SPR EA1N and EA2 PROJECTS

DEADLINE 9 – COMMENTS ON NATIONAL GRID SUBSTATION EXTENSION APPRAISAL

Interested Party: SASES **PINS Refs:** 20024106 & 20024110

Date: 15 April 2021 **Issue:** 1

SuDS Basin Overlay Plans

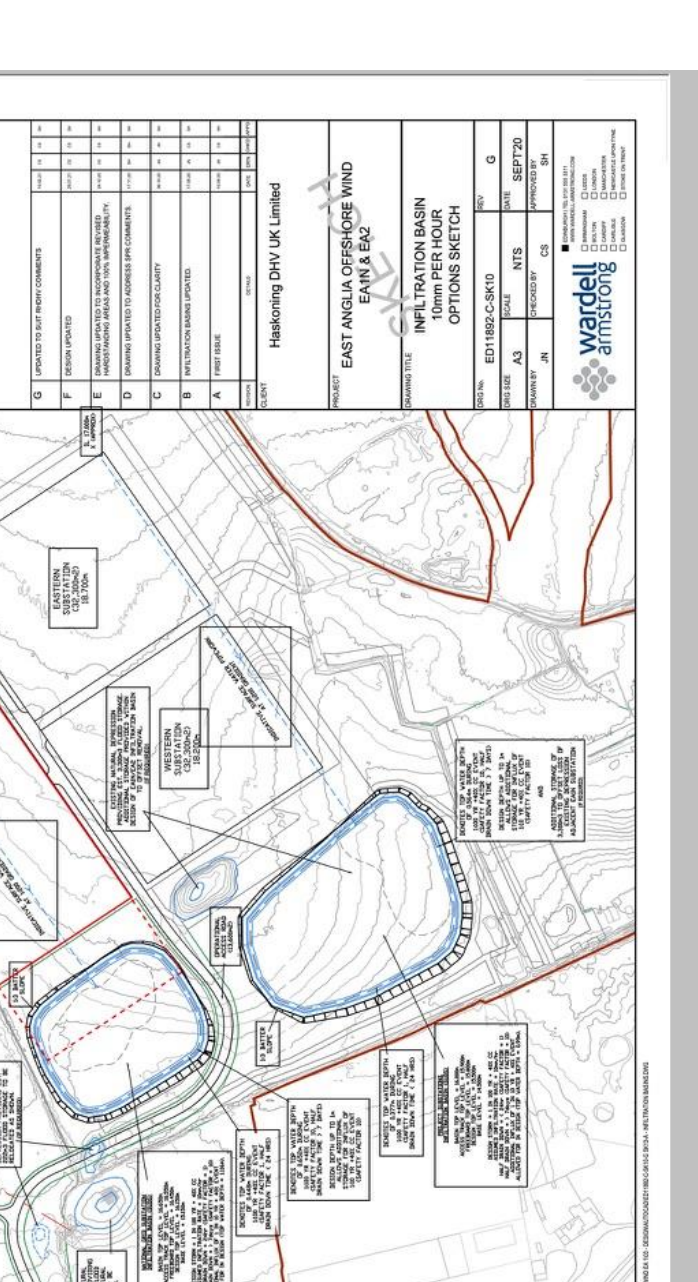
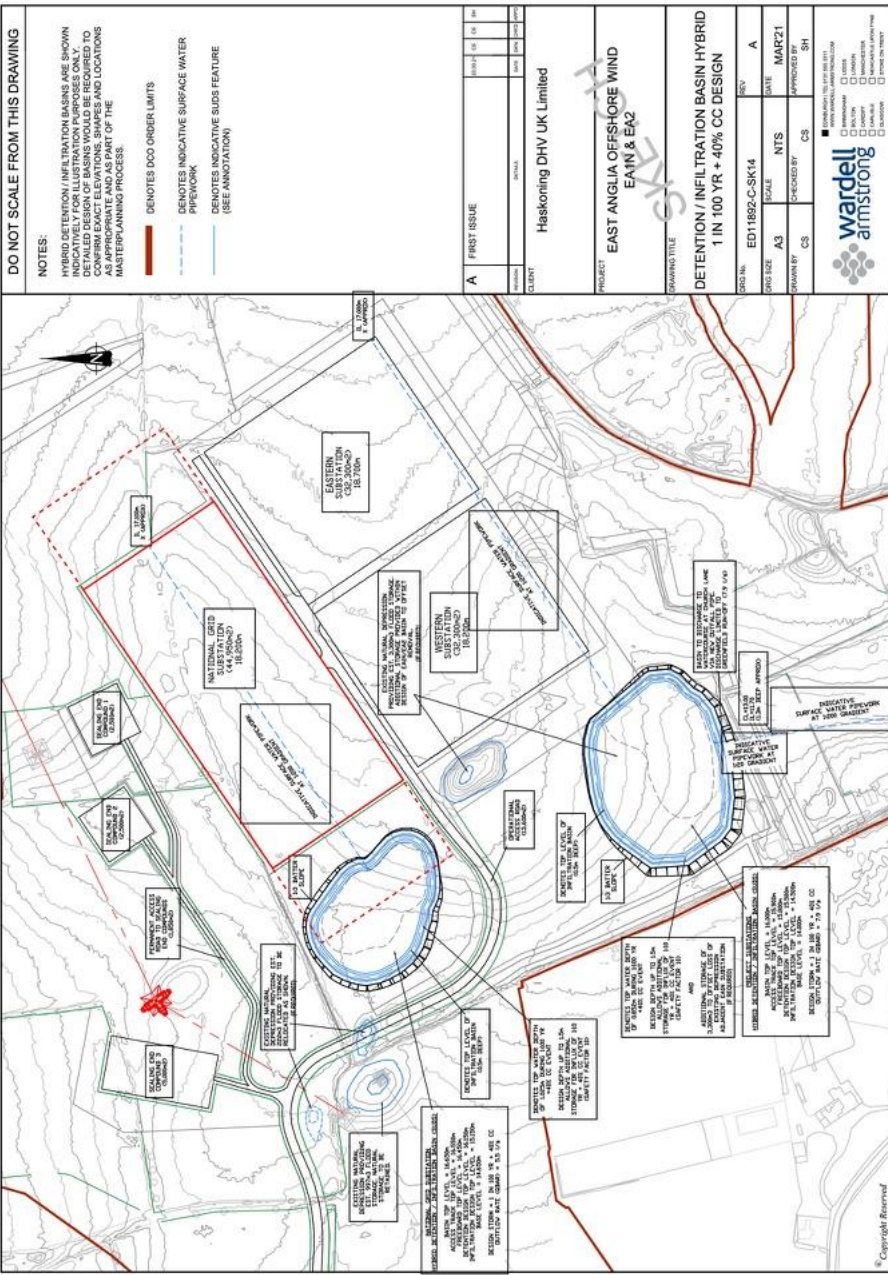
OODMP the south-west extension will encroach very substantially onto the SuDS basin to the north whether on infiltration basis or on a hybrid basis – see Appendix 1, where figure 1 of the appraisal is overlaid on the plans attached to the latest OODMP. Also the level of encroachment is severe. The Applicants must explain how the further additional flood risk can be mitigated and how the flood risk from the EA1N and EA2 developments will be mitigated given the level of encroachment to the northern SuDS basin. See further the report of GWP consultants attached to SASES' Deadline 9 Submission on Flood Risk referred to above, pages 6 and 7.

6. The location of the western NG extension would overlap with the proposed area for one of the SUDS the drainage basin. This would be true for the drainage basin as currently shown on the OLMP and there would be an even greater overlap if the larger infiltration ponds were implemented.⁵ This
